PROJECT: CONNOR HILLS

CITY OF LAS VEGAS INTER-OFFICE MEMORANDUM

Drainage Study for:
Connor Hills

This letter is submitted in response to your review memorandum dated August 7, 2014, regarding the above referenced project. A copy of the City of Las Vegas (CLV) Department of Public Works comment letter has been provided in Appendix A and the comments have been individually addressed as follows:

RICHMOND AMERICAN HOMES
CONNOR HILLS
GRADING PLAN

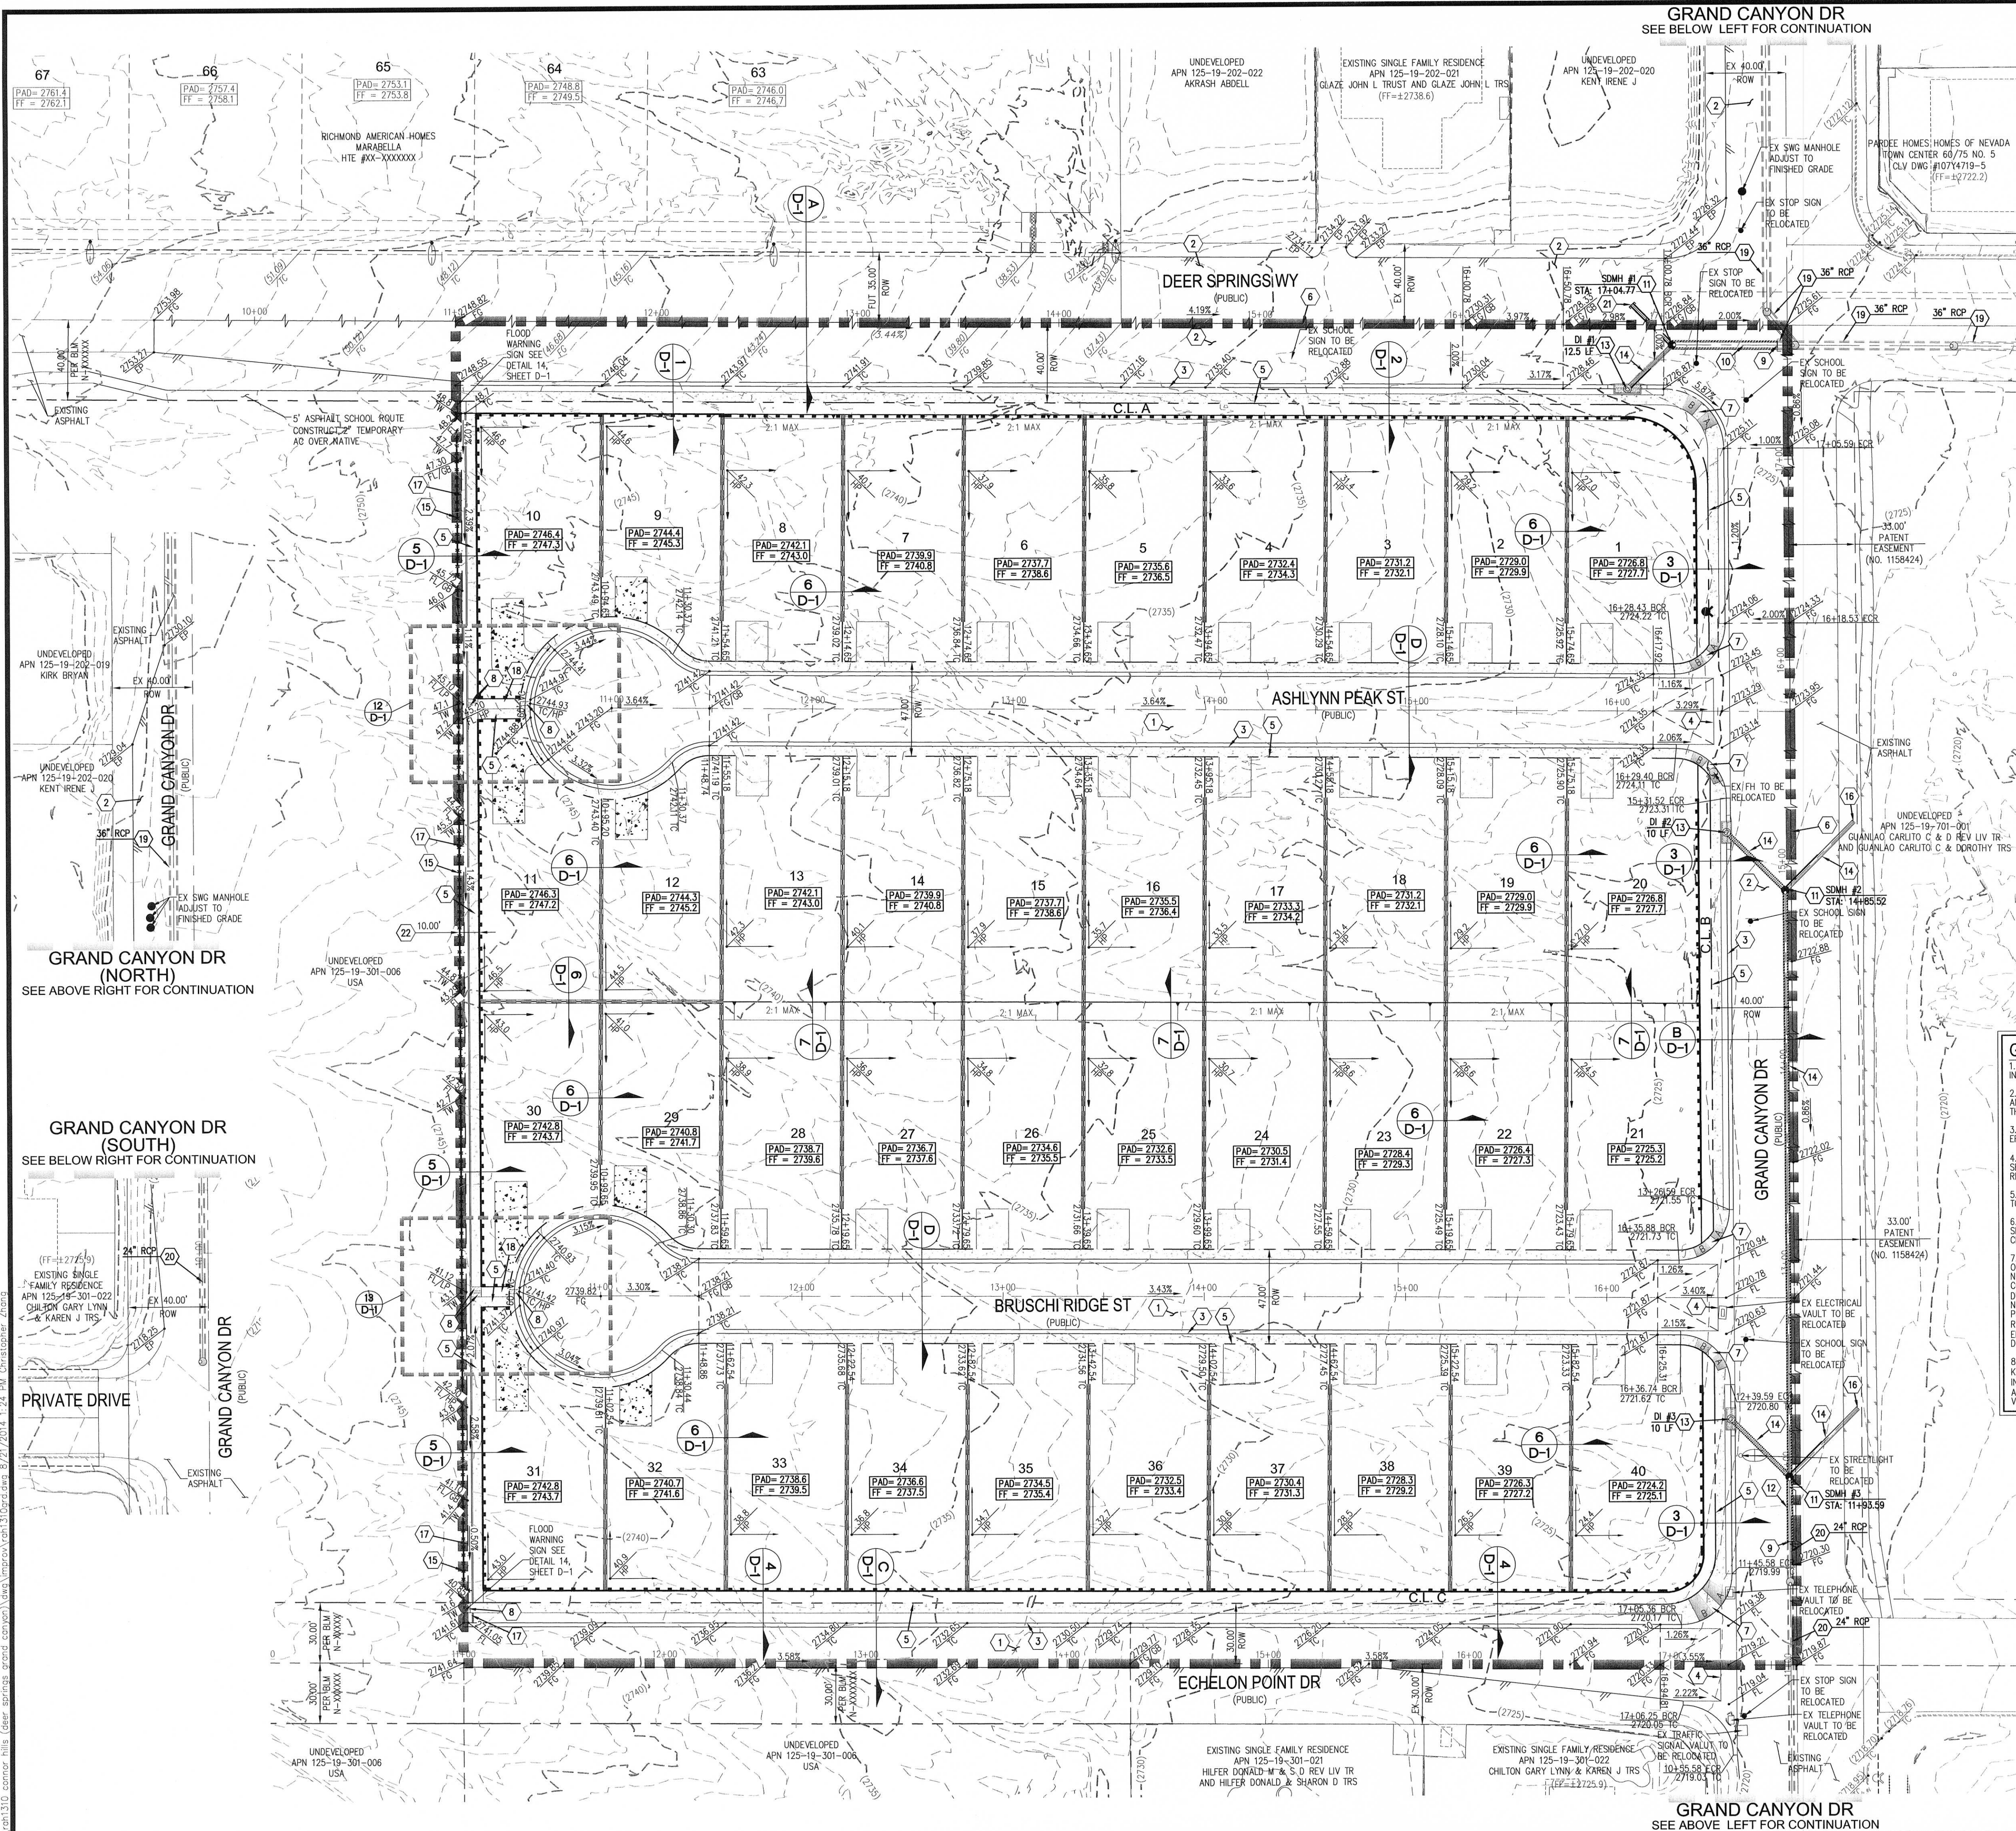
8. **Comment:** *Label the slopes in the bulbs of the cul-de-sac of Pinley Rise Street and Luck Summit Street on the grading plan. The Clark County Regional Flood Control District Manual requires 1 % minimum slope around the bulb of a cul-de-sac where storm water is drained through in Section 1602.*

9. **Comment:** *Label the existing storm drain systems in Deer Springs Way and Grand Canyon Drive with City of Las Vegas recorded plan numbers on the grading plan.*

Response: Noted. All cul-de-sac bulb slopes have been labeled and are shown to maintain more than the minimum of 1.0%.

Response: The existing storm drains in Deer Springs Way and Grand Canyon Drive have been labeled with their recorded CLV plan numbers. See construction notes 19 and 20.

STORM DRAIN LATERAL #5

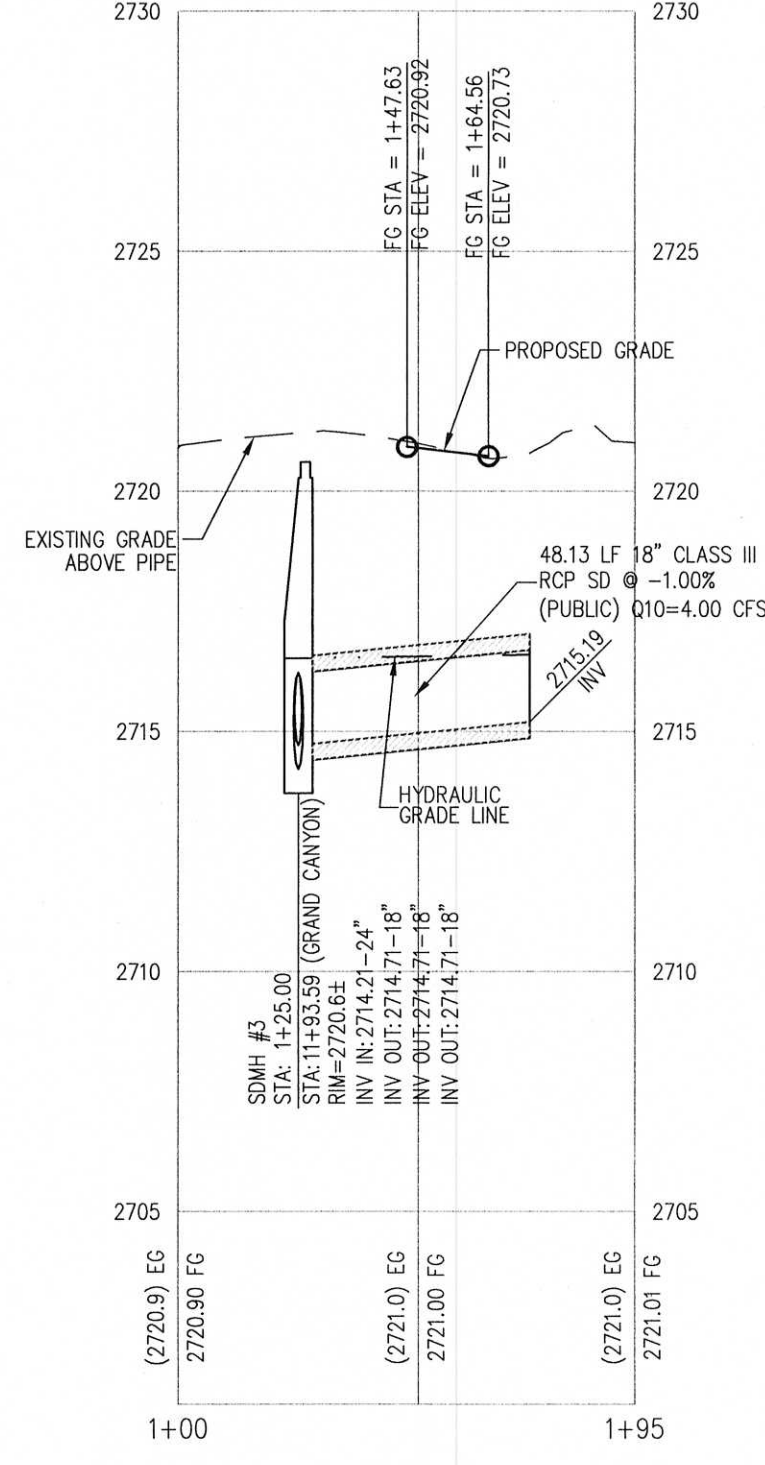
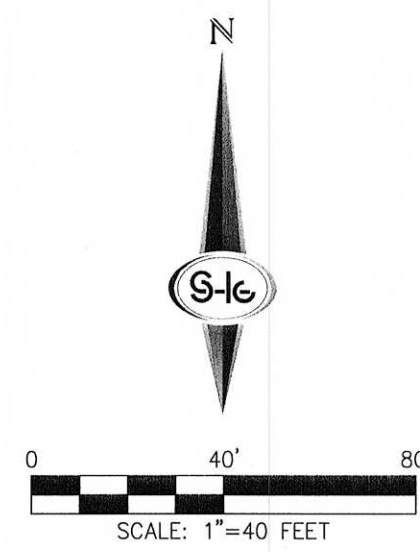
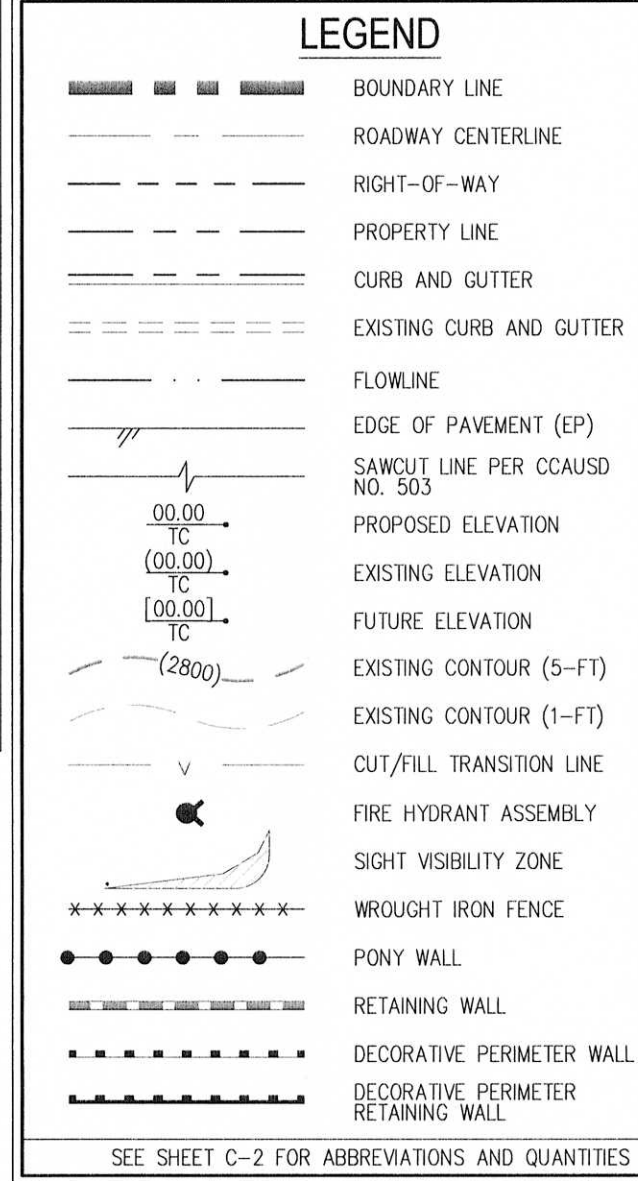
5. **Comment:** *Extend a lateral at SDMH #1 beyond the center line of Deer Springs Way for future inlet connection on the north side of the street.*

Response: The lateral at SDMH #1 has been extended beyond the center line of Deer Springs Way as noted. Please refer to the revised plans provided with this submittal.

21. CONSTRUCT STUB AND CAP 10' PAST CENTERLINE OF DEER SPRINGS WAY.
 22. DRAINAGE AND PEDESTRIAN ACCESS EASEMENT TO BE PRIVATELY MAINTAINED.
- SEE SHEET C-2 FOR ABBREVIATIONS, LEGEND & QUANTITIES
